# Central Falls High School

## 100% Construction Documents

### **Addendum #12**

February 20, 2024

DRAWN BY: J. FIGLIOZZI, E. LIMON  
REVIEWED BY: S. D'AMBROSIA, J. ROBERTSHAW  
SCALE: 1"=40'-0" DRAWING NUMBER:  
JOB NO.: K1031 **L1.01**  
DATE: OCTOBER 13, 2023

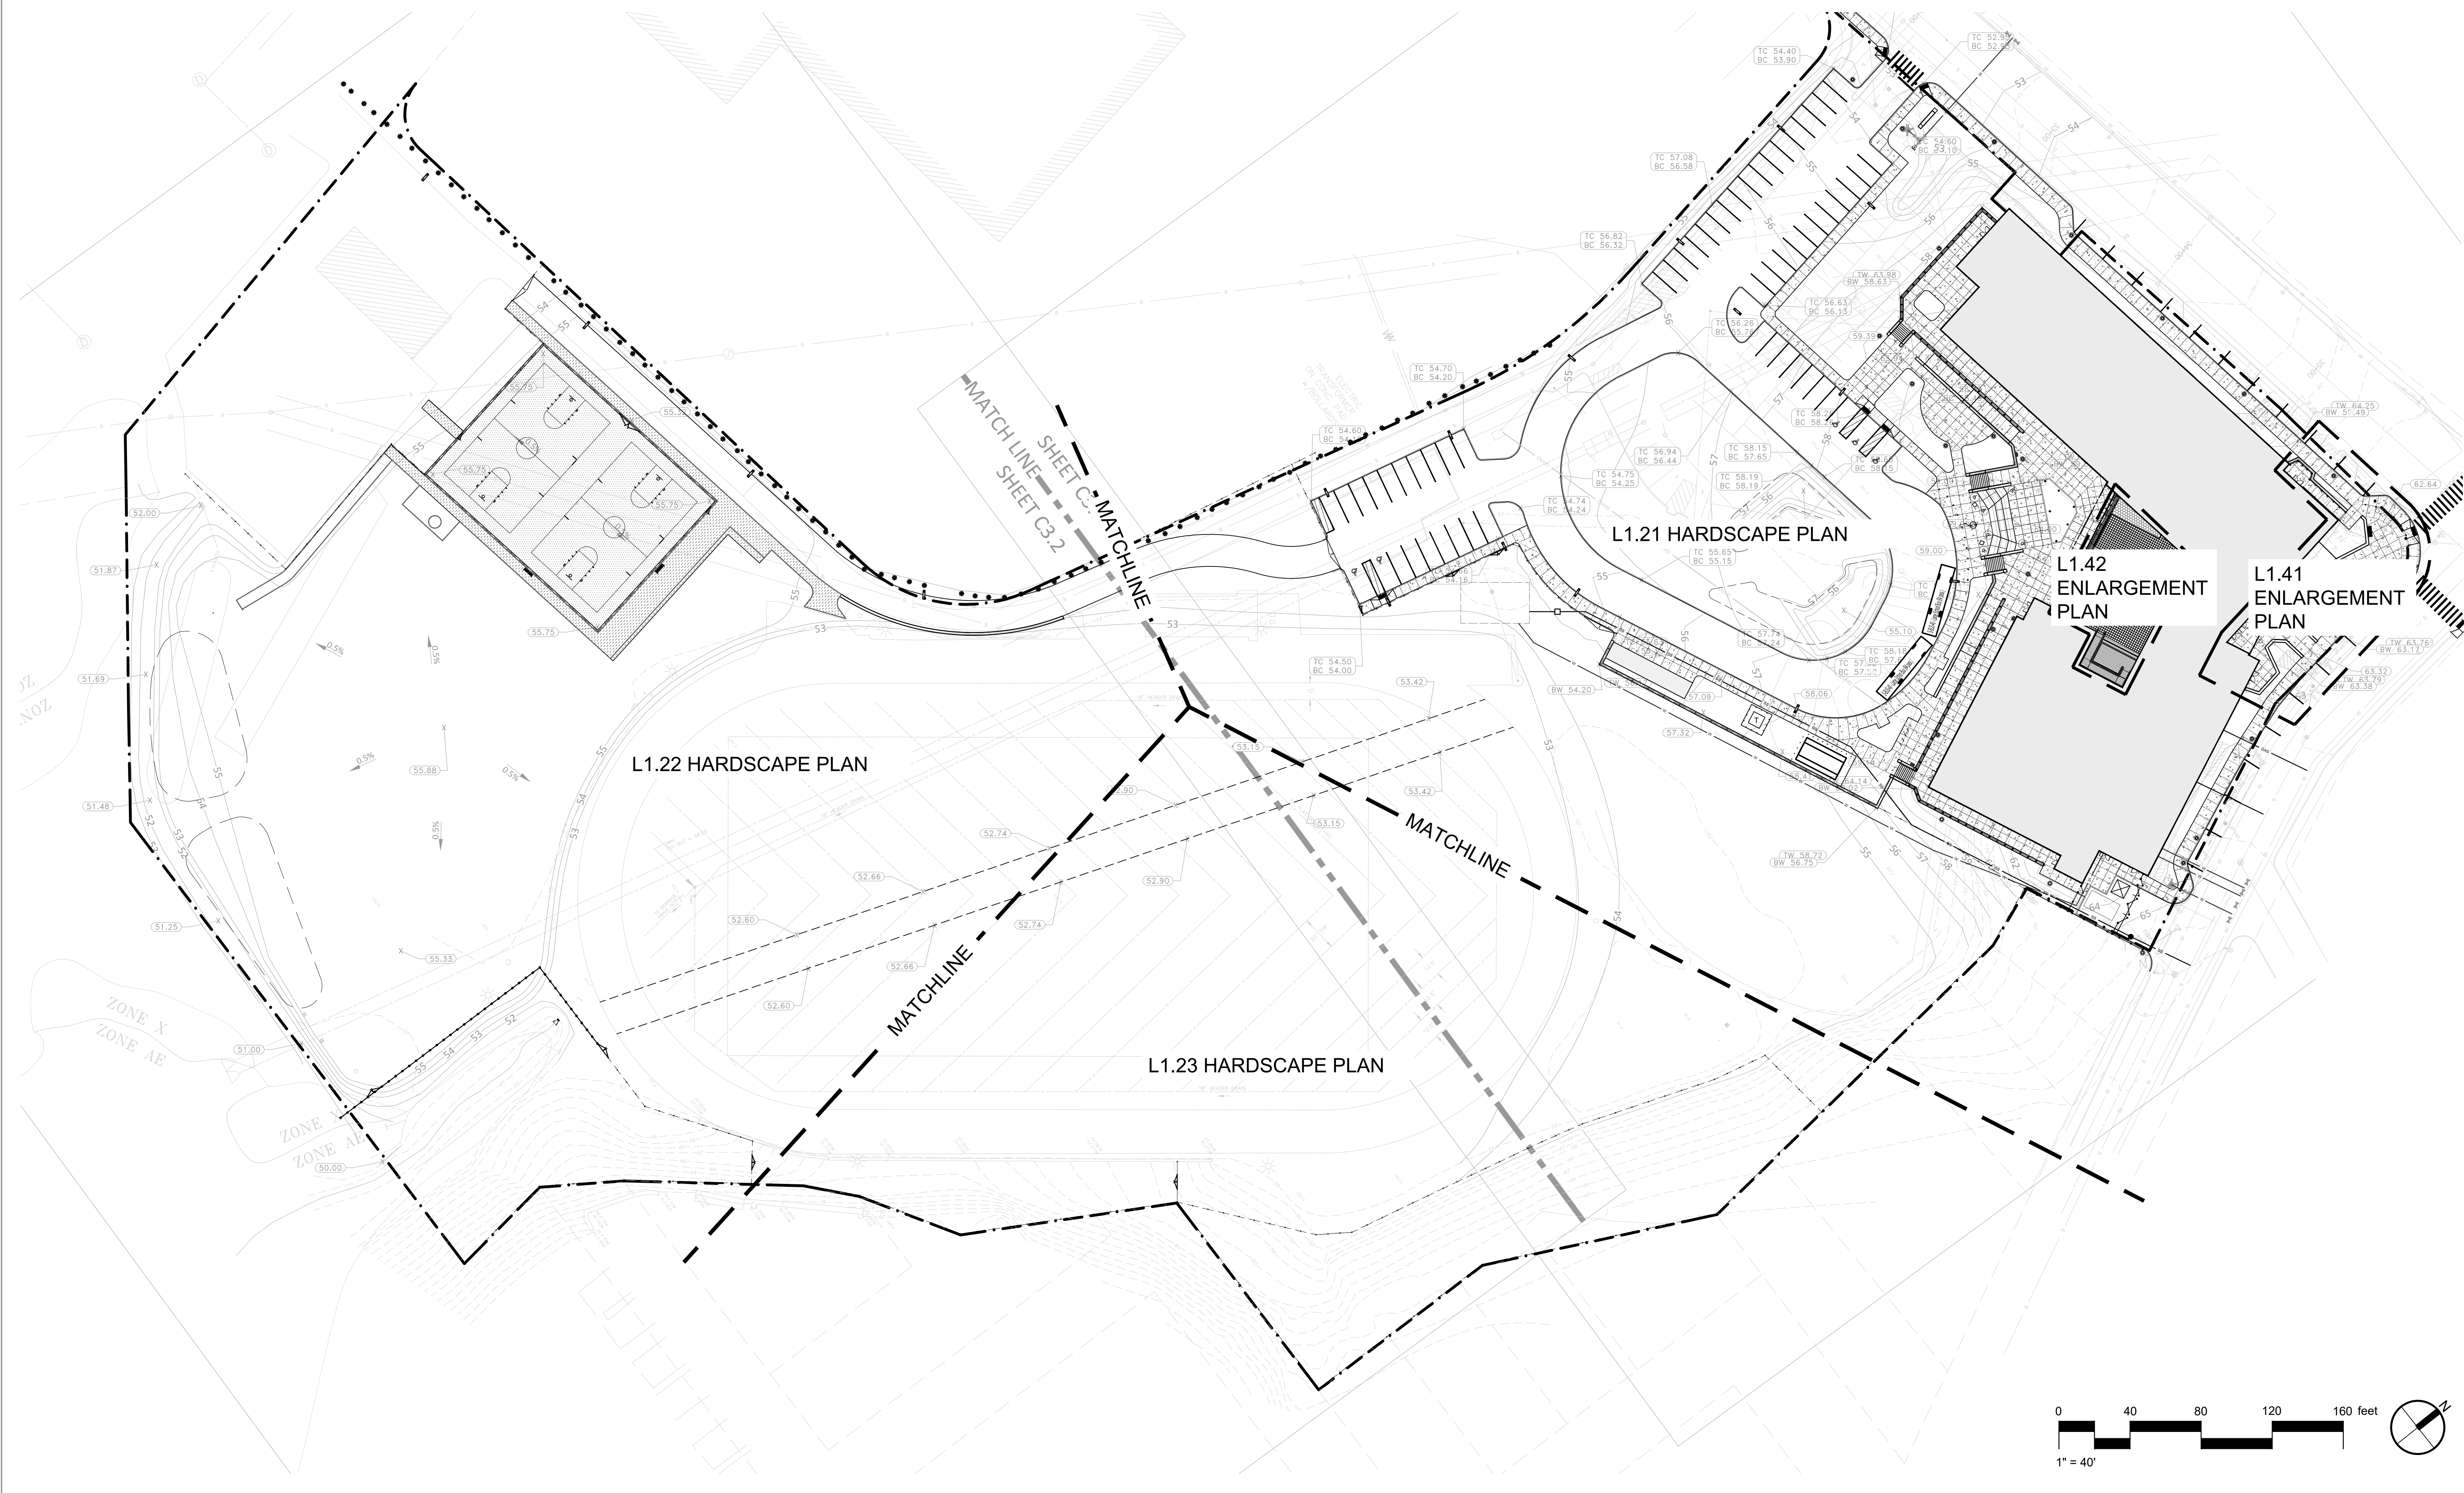
ADD 11  
QUANTITY CHANGES TO SPLIT RAIL FENCE AND BITUMINOUS ASPHALT

SCALE: 1"=20'-0" DRAWING NUMBER:  
JOB NO.: K1031  
DATE: OCTOBER 13, 2023 **L1.21**

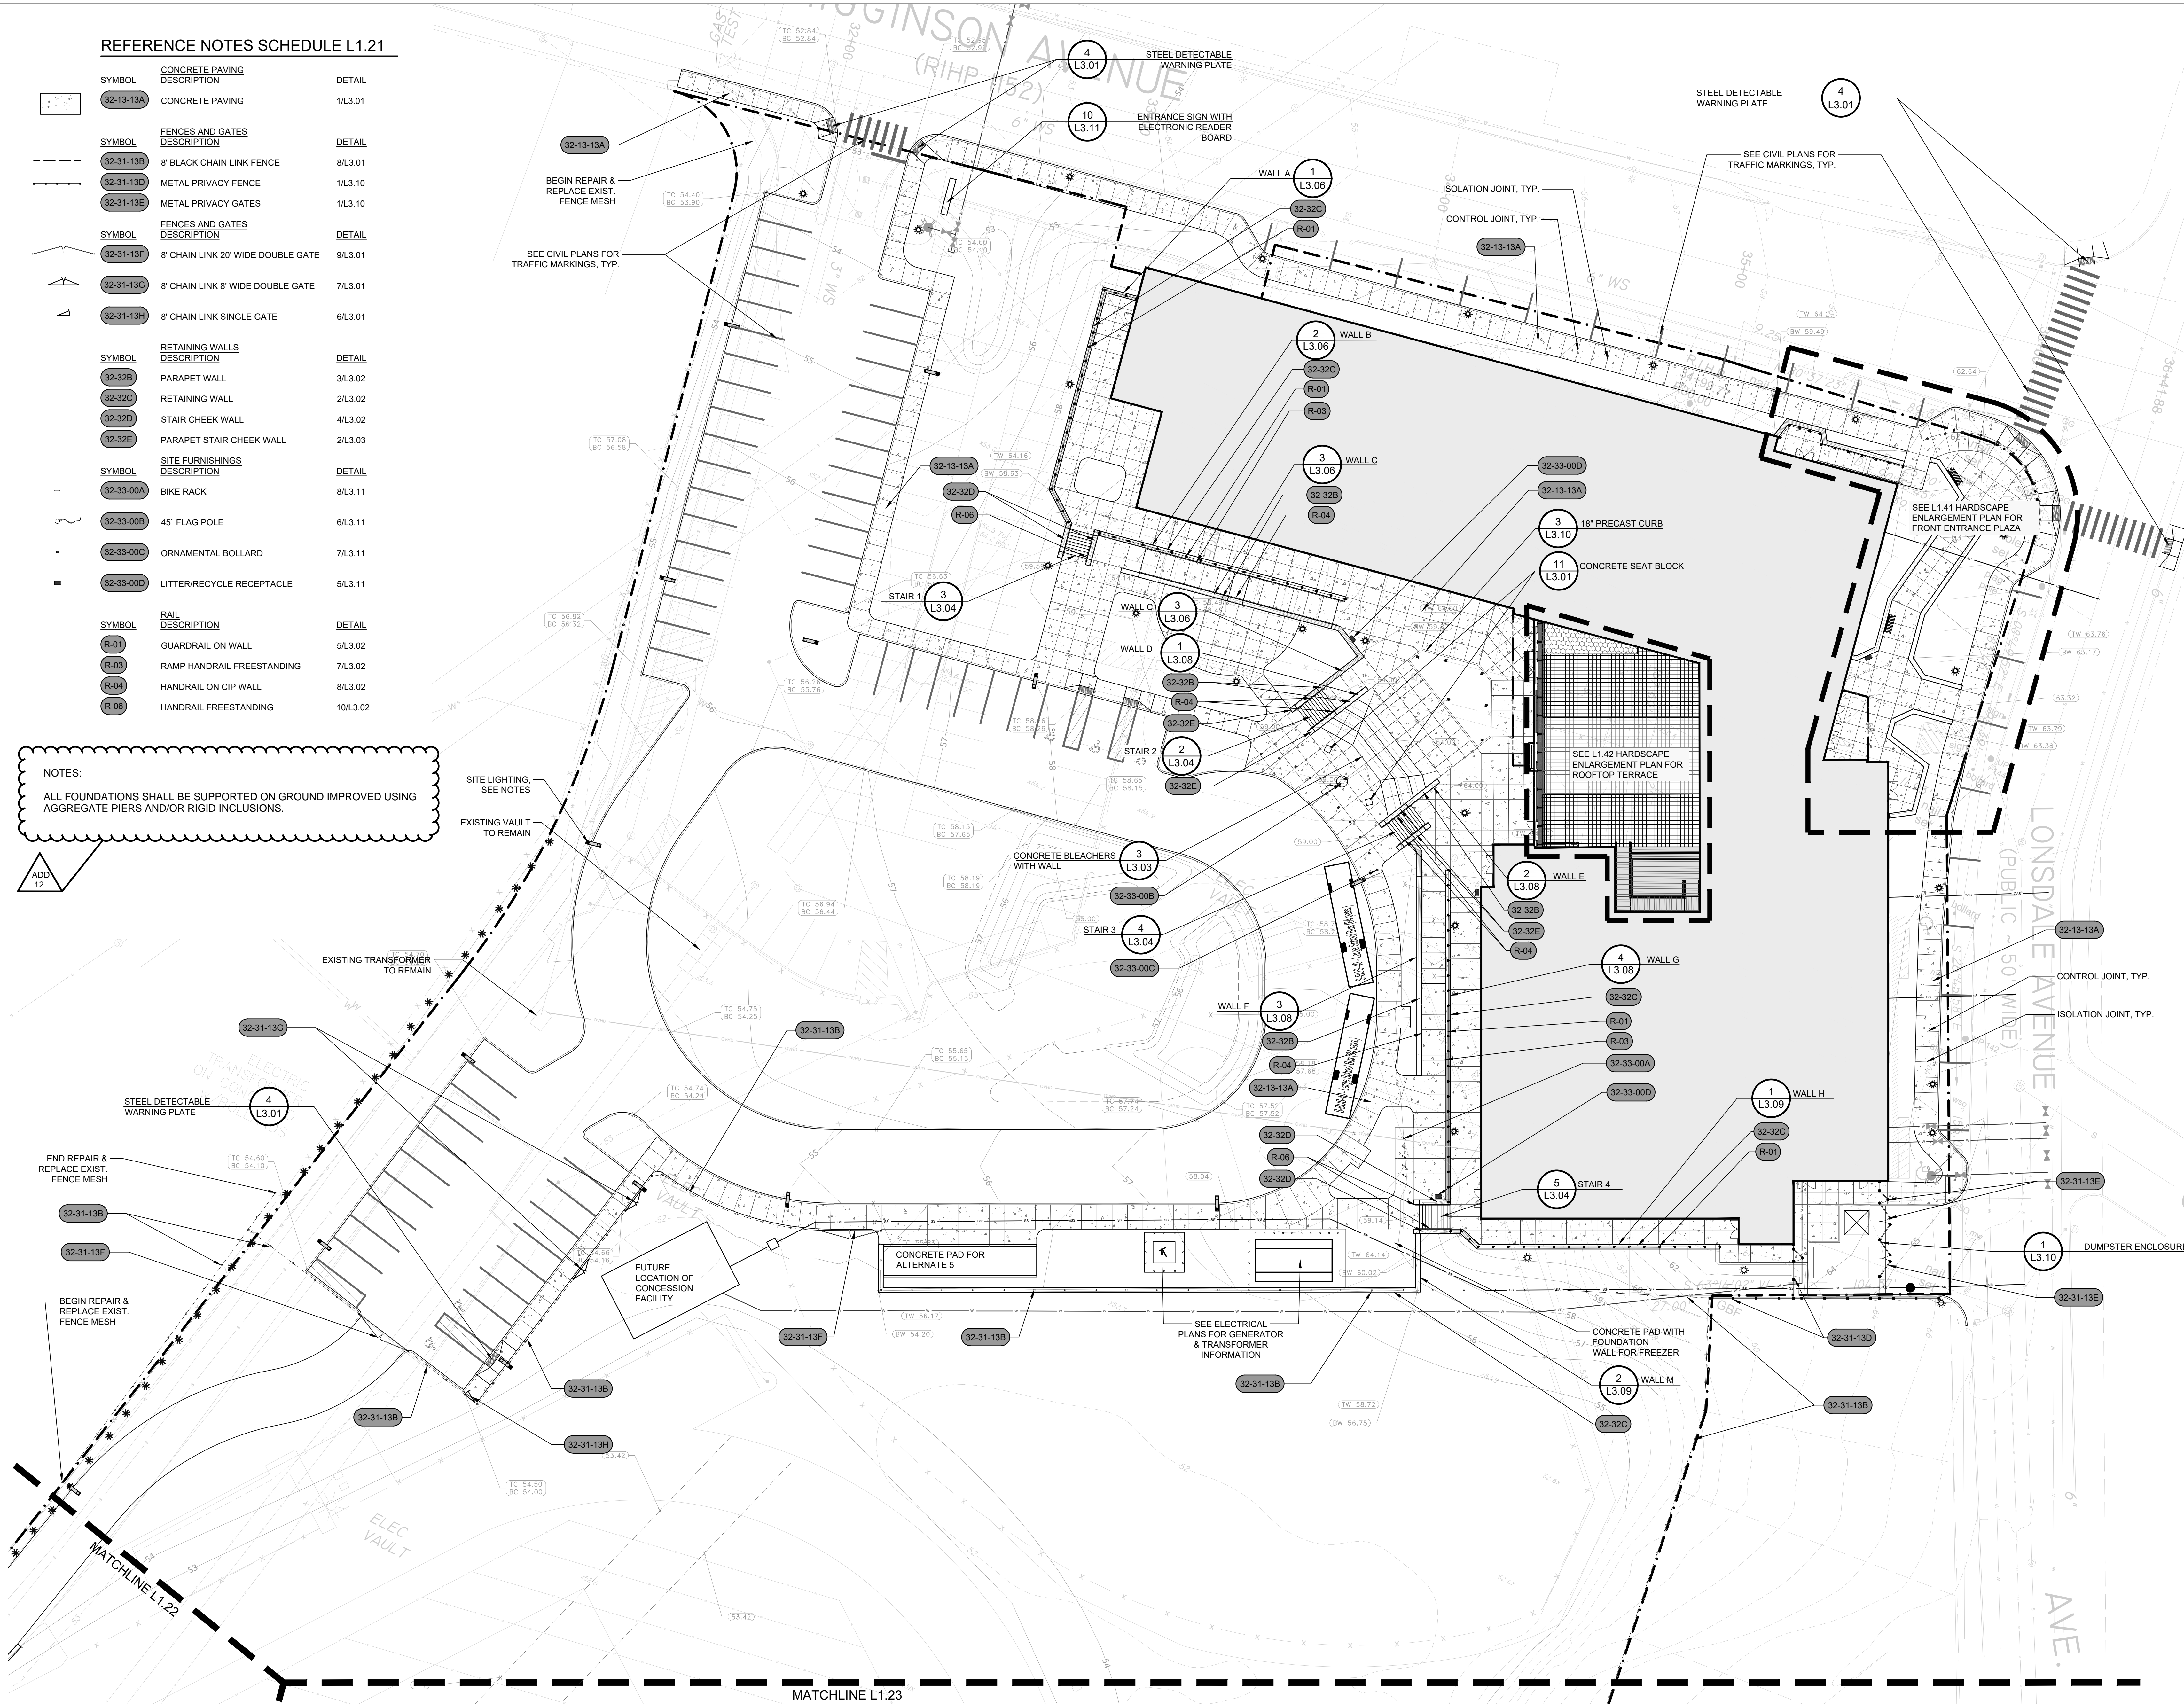
ADD 12  
NOTES:  
ALL FOUNDATIONS SHALL BE SUPPORTED ON GROUND IMPROVED USING AGGREGATE PIERS AND/OR RIGID INCLUSIONS.

2 PARAPET STAIR CHEEK WALL

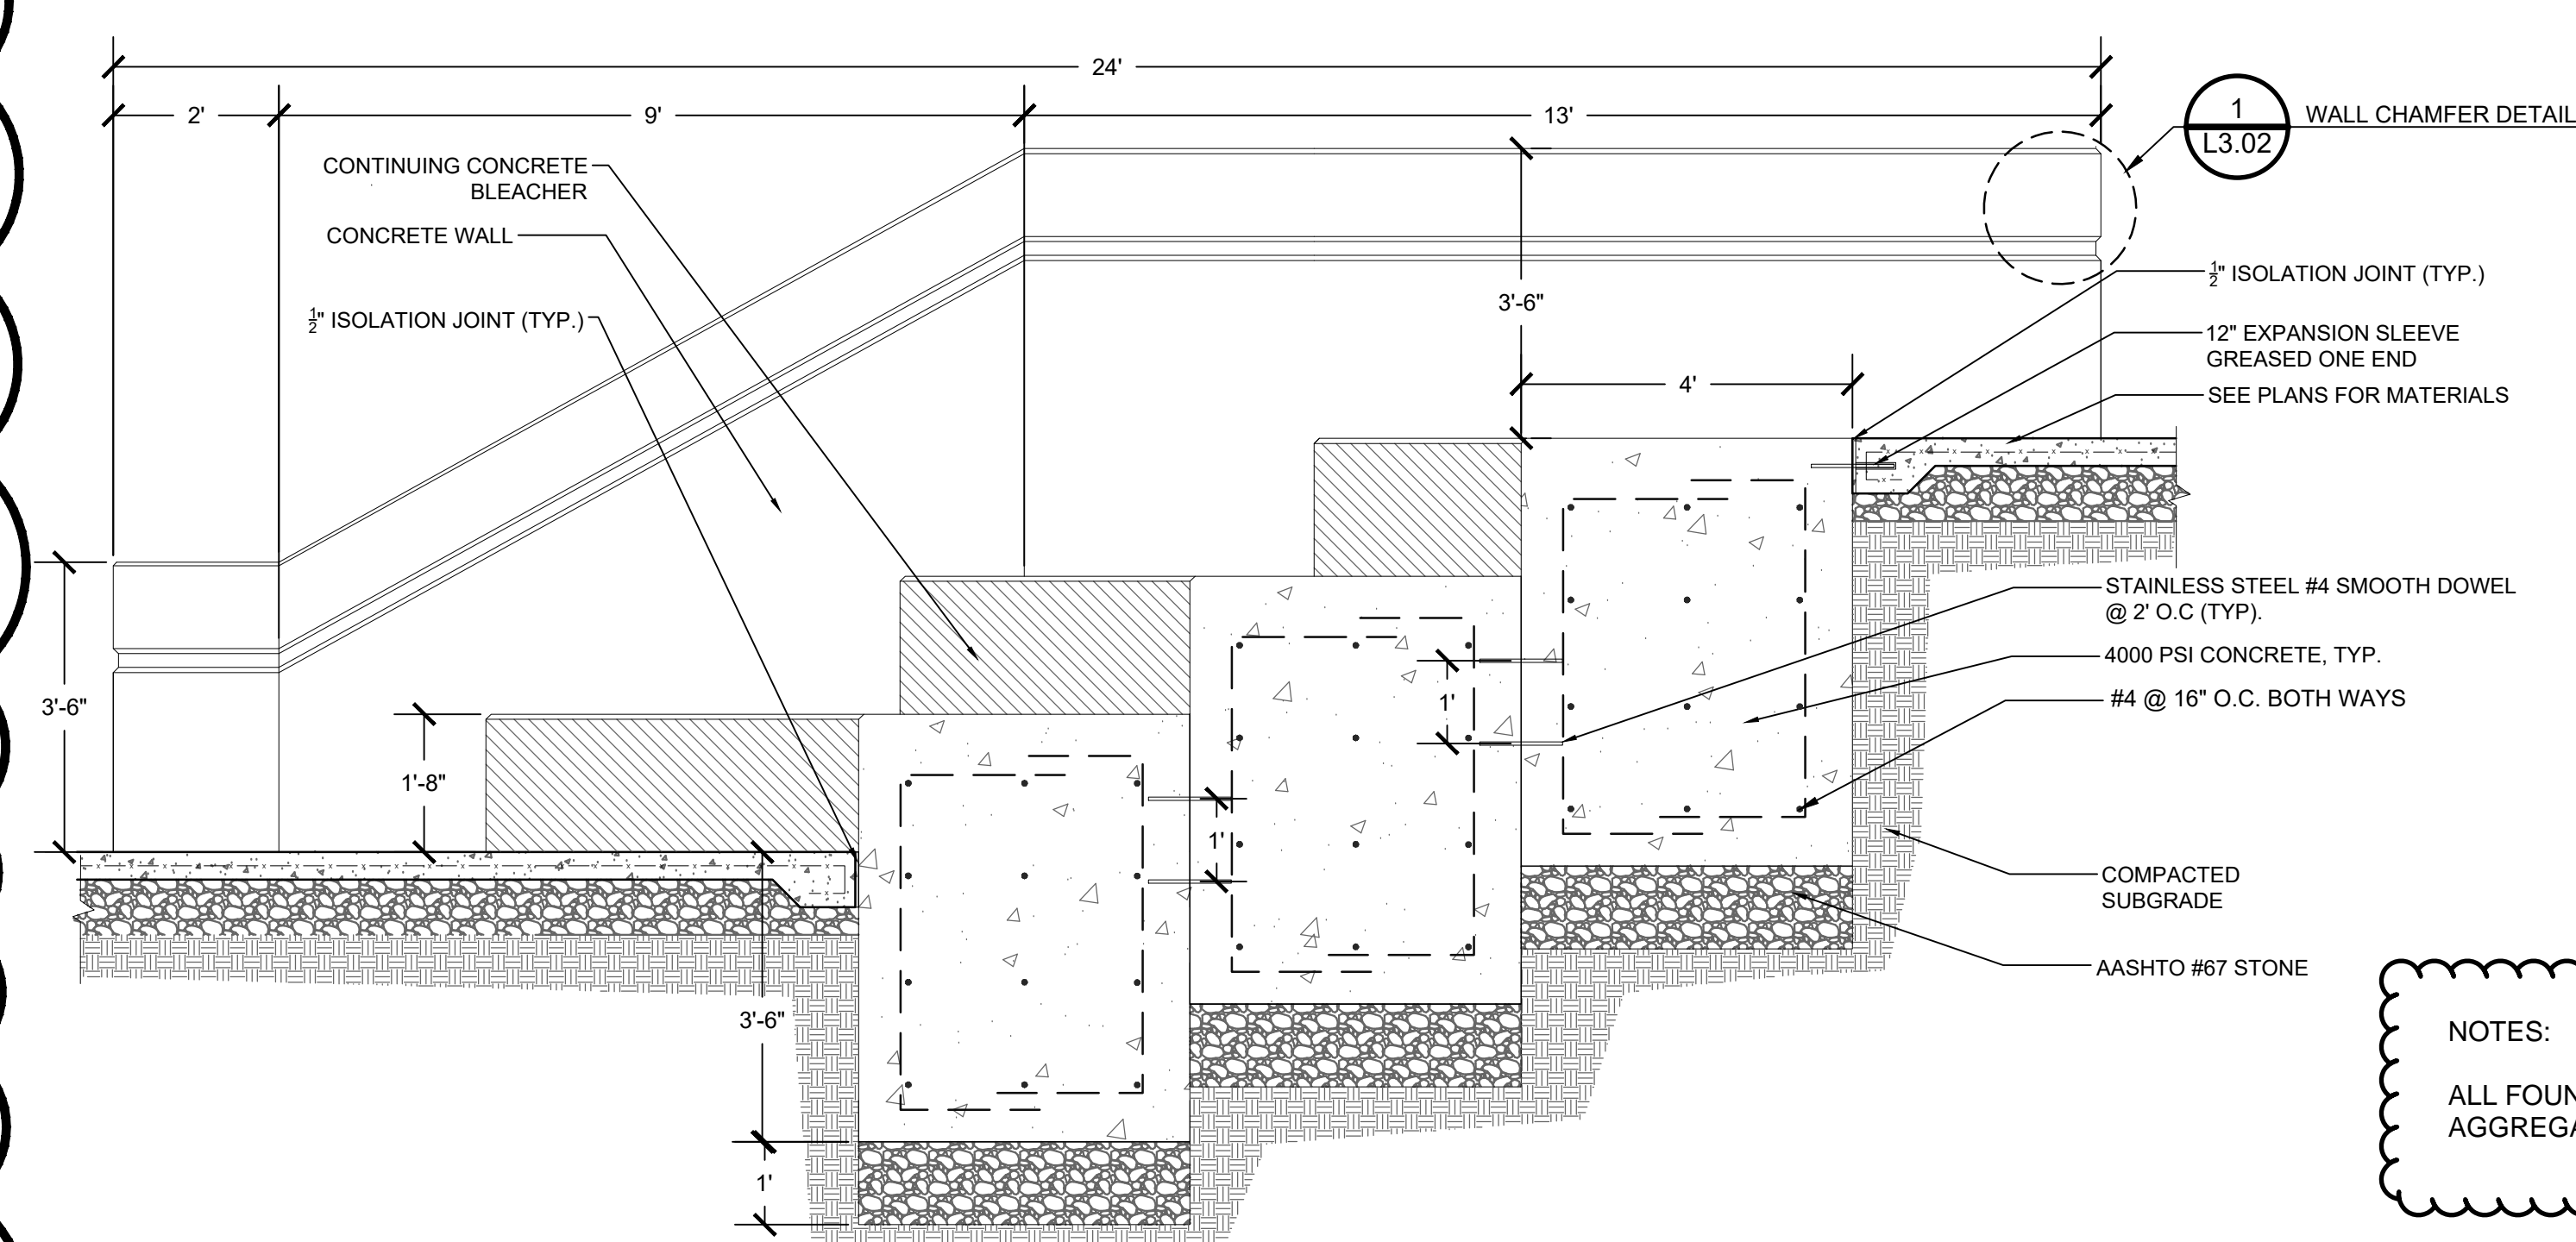
**ADD 7**  
FOOTING DEPTH CHANGED FROM 3' TO 3'-6"  
ISOLATION JOINT CALLED OUT ON BLEACHER SIDE OF WALL  
DIMENSIONAL CORRECTION FOR HEIGHT OF WALL
